SUBJECT: FWD TRANSIT PUMP / BRAKE LINE LOCATION

SERVICE MEMO. 14-01-23

DATE: JANUARY 2014

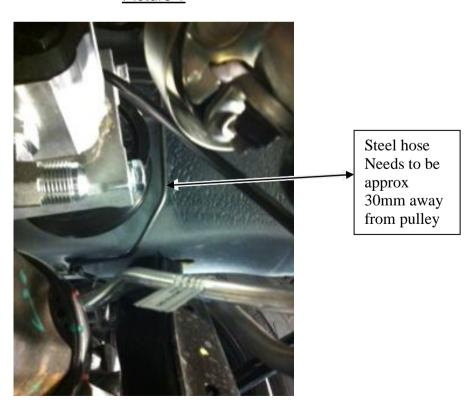
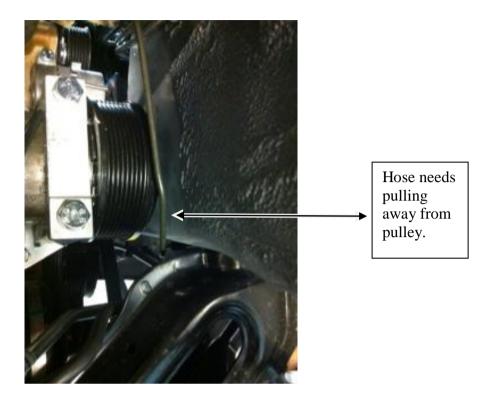
We have had one reported incident that the hydraulic pump fitted to the rear of the engine can come into contact with one of the steel brake lines even though the pump is fitted to the exact same position that Ford fit the air conditioning pump.

We are therefore contacting all our customers who have purchased the Front Wheel Drive Transits and asking them to check the proximity of the steel brake hose to the rear of the pump drive pulley.
